### 7. FLORA AND FAUNA

## **DIRECTOR-GENERAL'S REQUIREMENTS**

- **7.1** Flyers Creek Wind Turbine Awareness Group objects to the proposal:
- 7.1.1 No **Soil** and **Water Management Plan** for either the construction or the operational phase of the project is presented as part of the Environmental Assessment. Leaving this plan to be developed as part of the Conditions of Consent has meant that there can be no public comment on this important aspect.

Figure 7.1 GAP ROAD CARCOAR.

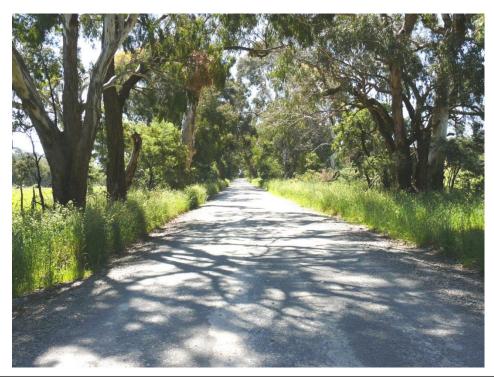
- reproduction of bird species such as the parrots (eg. superb parrot a vulnerable species).
- 7.2.3 No survey was conducted of roadside vegetation, often the location of vestigial native vegetation, despite the fact KMA states there are some "small patches of native grasses on rocky sites and road sides". Some areas of roadside have significant mature trees, with hollows (Figures 7.1 and 7.2).

- 7.2.4 There are 80 kilometres of narrow, poorly maintained, often gravel roads that are expected to provide access to the proposed wind turbine sites. Many are less than 5 metres in width and it is axiomatic that these roads will require widening to accommodate a large number of over size, over long and over weight vehicles. Because of this almost all roadside vegetation and large trees will almost certainly be removed or cut back. This will have a significant impact on the number of tree hollows available for nesting as well as vegetative corridor destruction.
